SUBJECT: PUBLIC HEARING – SPECIAL USE APPROVAL AND PRELIMINARY SITE PLAN REVIEW (SU JPLN2023-0002) - Proposed Kroger D-463 Fuel Station, West side of John R, South of Larchwood (PIN 88-20-26-435-029, 88-20-26-433-019, -020 & -021), Section 26, Currently Zoned IB (Integrated Industrial & Business) District

Preliminary Site Plan and Special Use Review For City of Troy, Michigan

Project Name:	Kroger D463 Retail Fuel Center
Plan Date:	April 28, 2023
Location:	SW Corner of Larchwood Drive and John R Road
Zoning:	IB, Integrated Industrial and Business
Action Requested:	Site Plan and Special Use Approval

**FUEL CENTER
 ELEVATIONS**

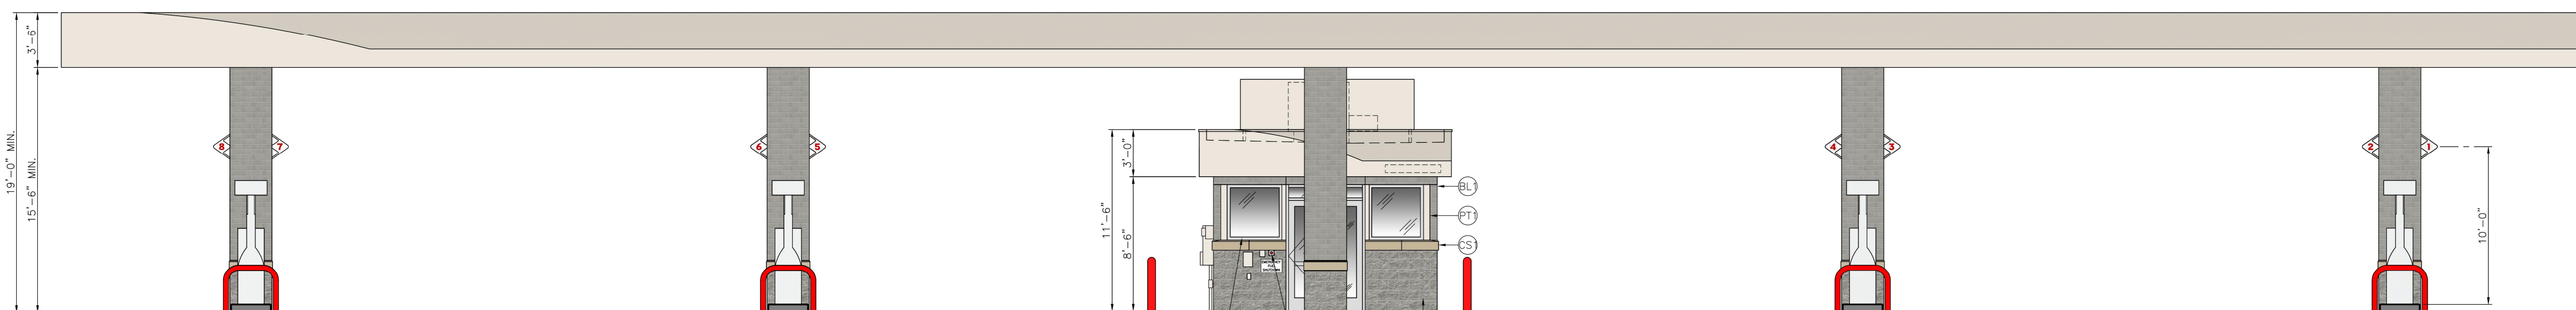
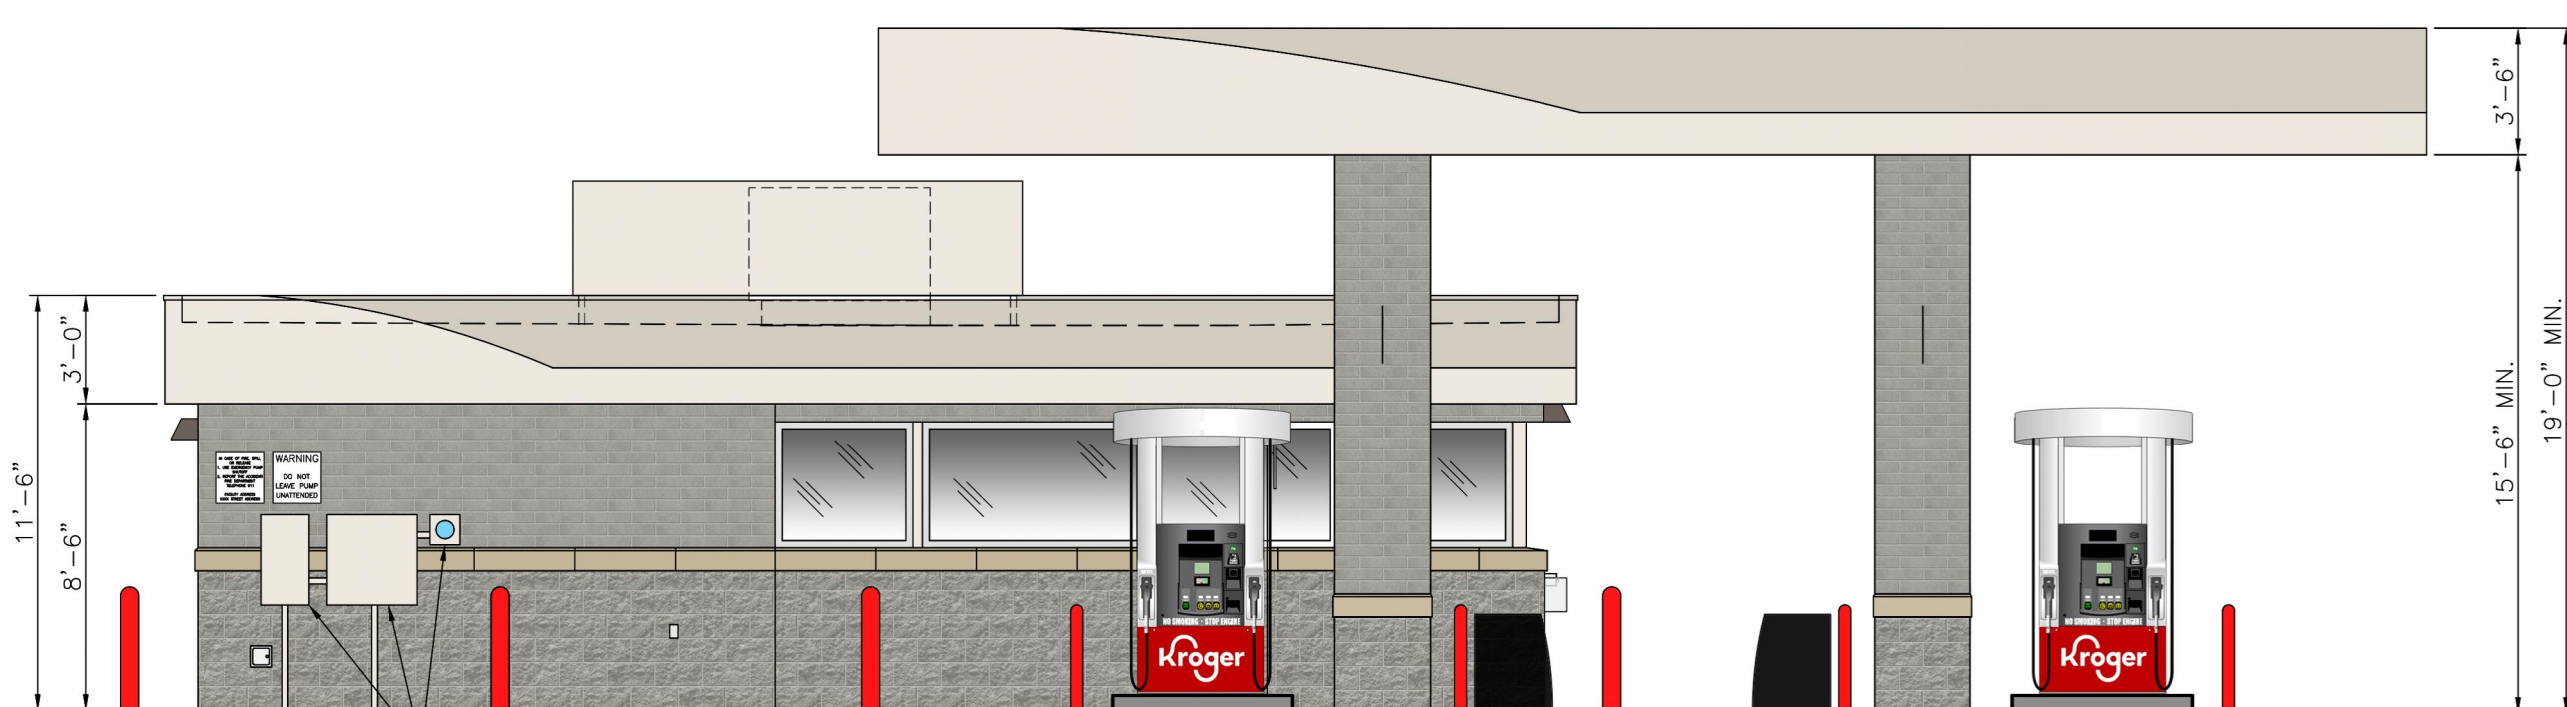
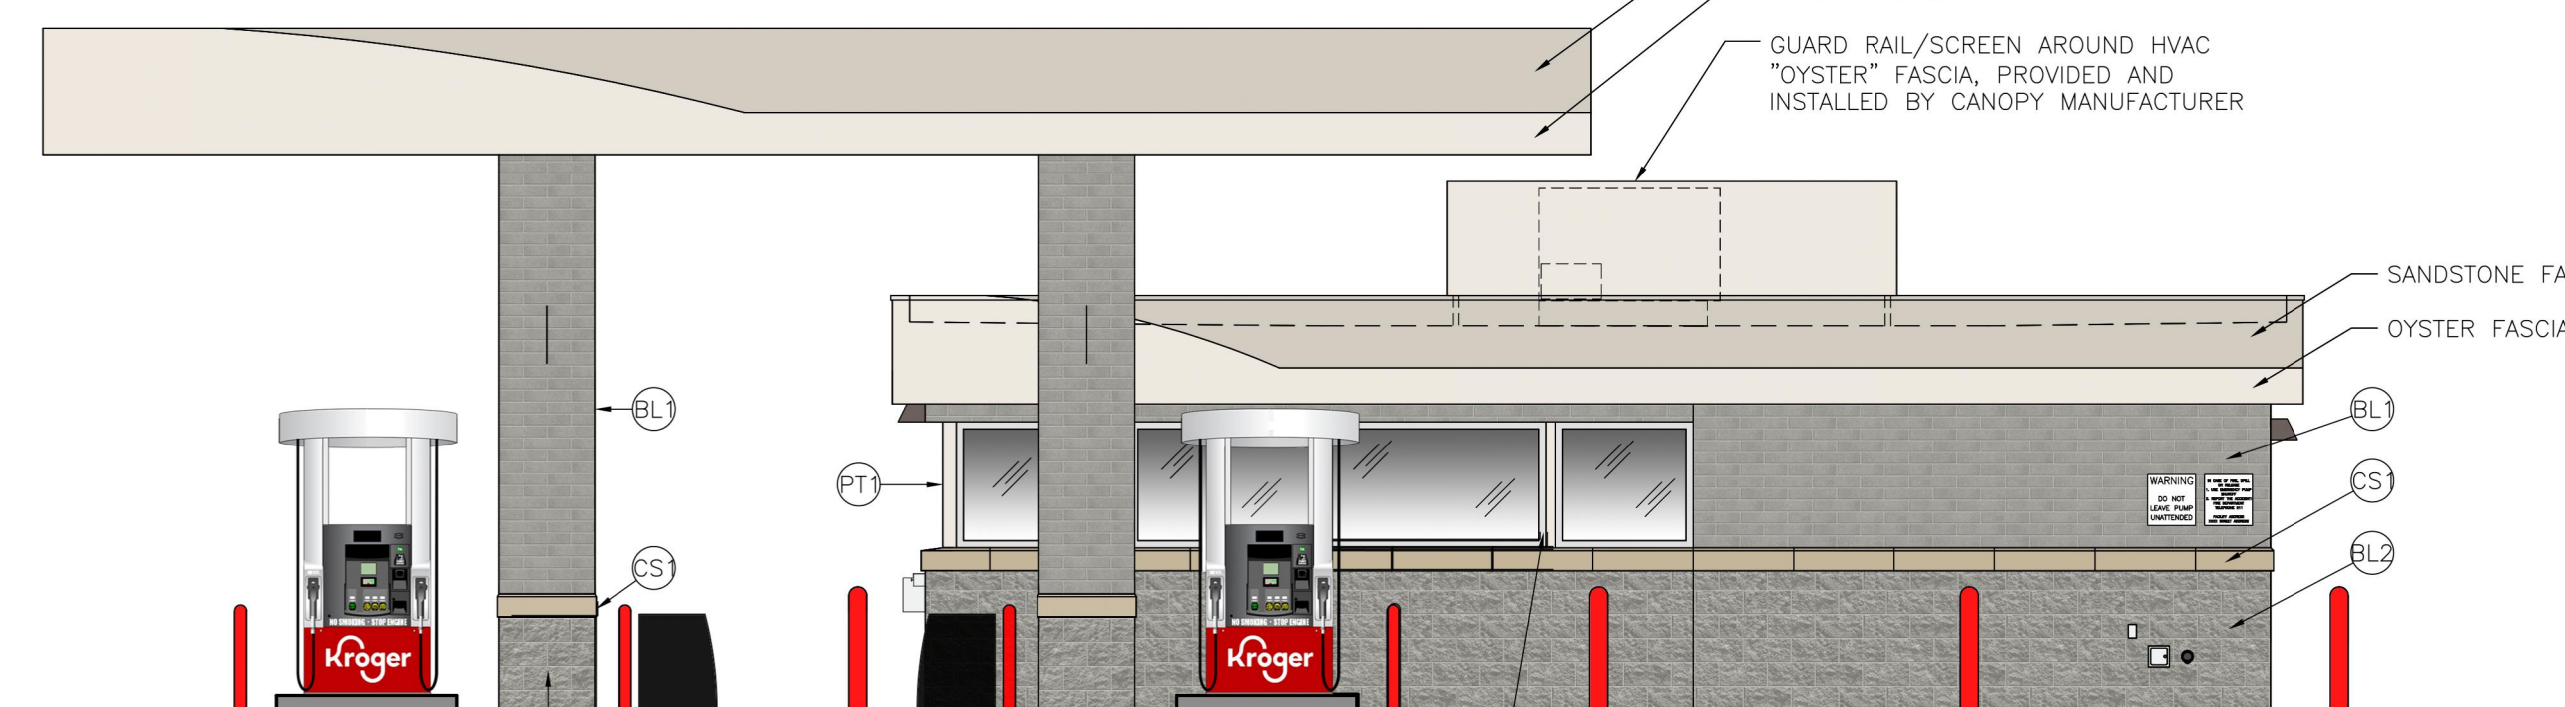
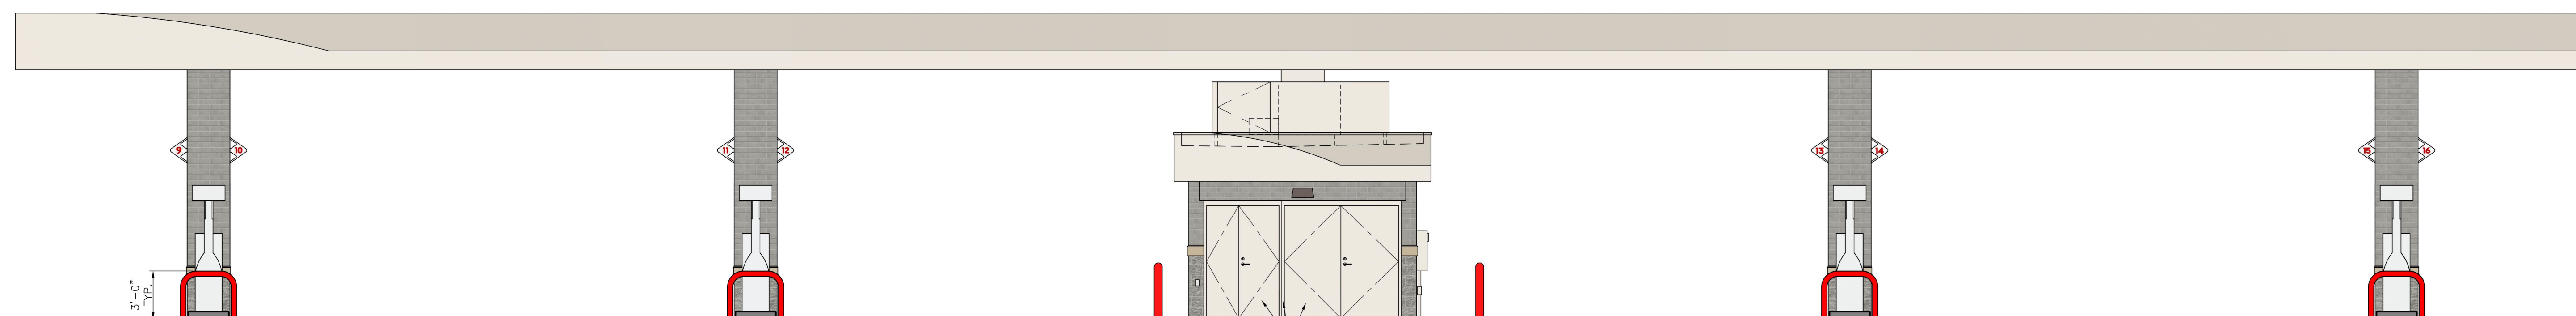
The applicant has provided elevations and floor plans for the transaction kiosk, canopy, and fueling stations. The elevations indicate a typical fueling center design with a CMU base, brick façade and metal fascia. The canopy matches the material of the building with a CMU base, brick façade and metal fascia. The canopy and kiosk fascia colors are sandstone and oyster, and six (6) red bollards are proposed around the kiosk perimeter.

To better understand the proposed color scheme, the applicant has provided a color rendering. Planning Commission should consider the proposed architectural details.

Items to be Addressed: Planning Commission should consider the proposed architectural details.
